PROJECT:
 WEST LAVINGTON
 PARKING RESTRICTION PROPOSALS

DRAWING TITLE:
 HIGH STREET, LITTLETON PAGNELL
 PROPOSED INTRODUCTION
 OF NWAAT

DRAWING TITLE:
 HIGH STREET / SANDFIELDS, WEST LAVINGTON
 PROPOSED INTRODUCTION
 OF NWAAT

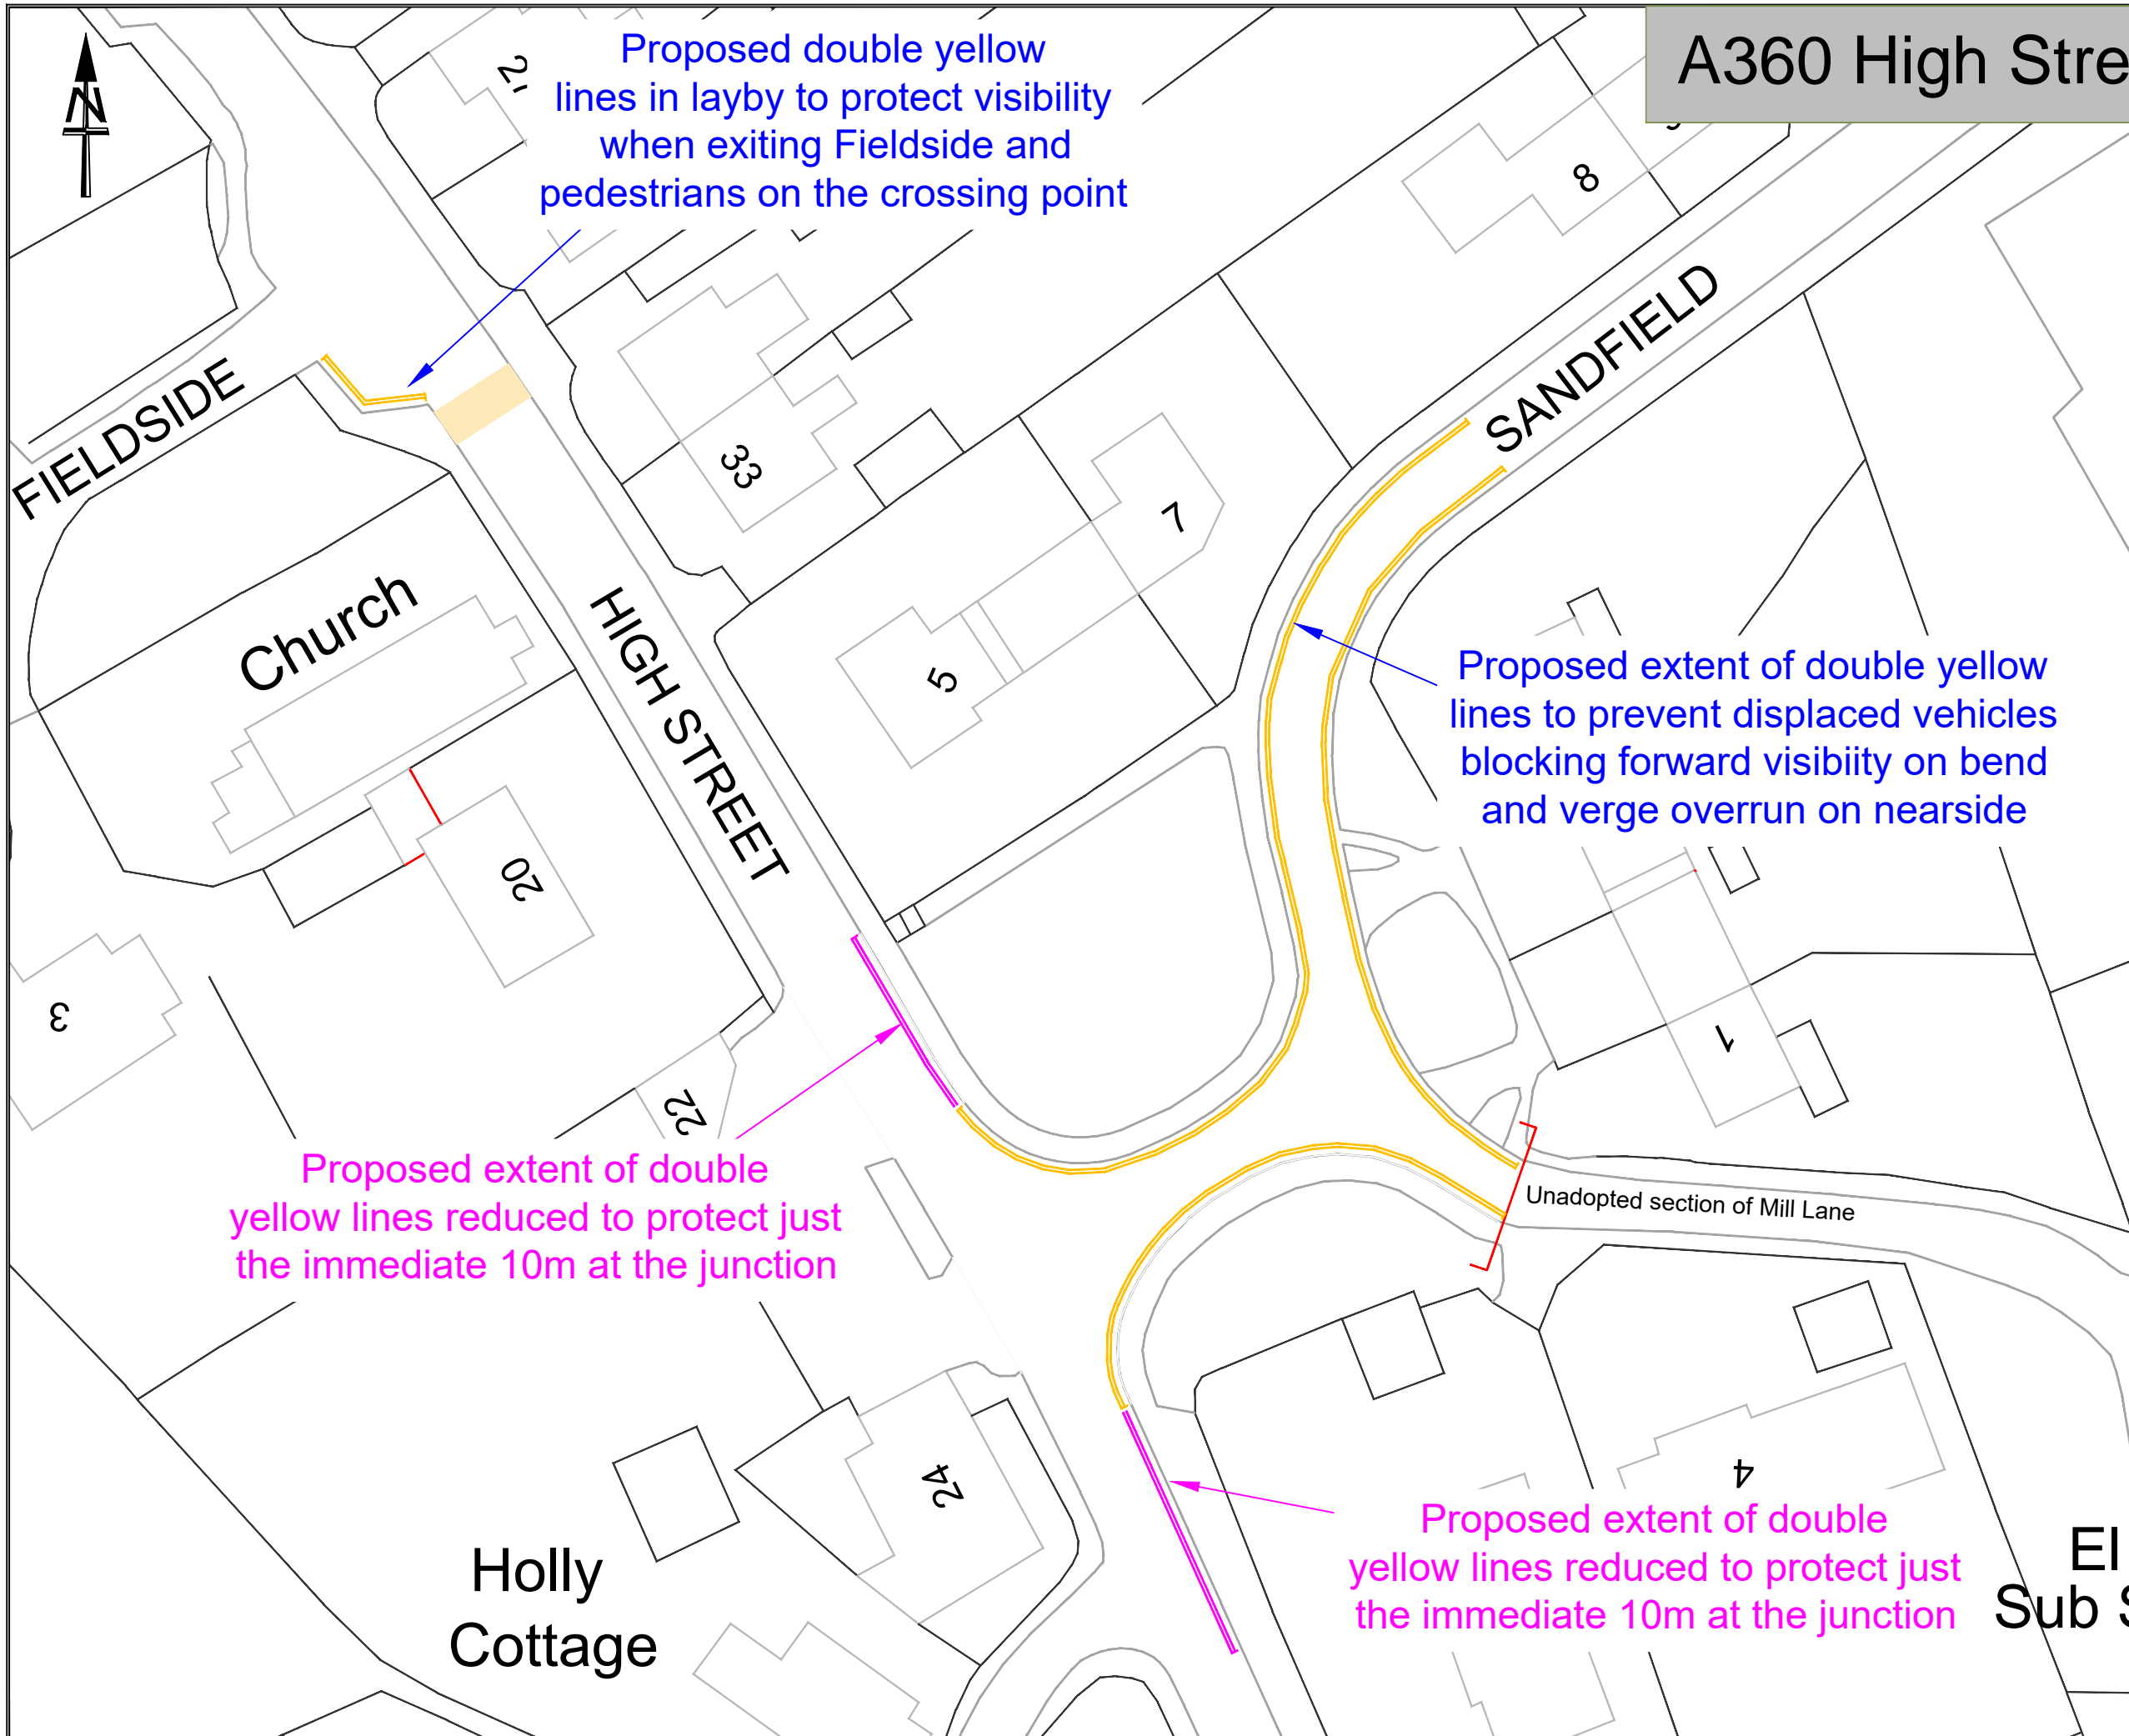
Proposed extent of double yellow lines reduced from 19m to 16m in order to maintain 3/4 parking spaces within the lay-by

Indicative drawing of proposal for clarification

White mark
agreed by
neighbours
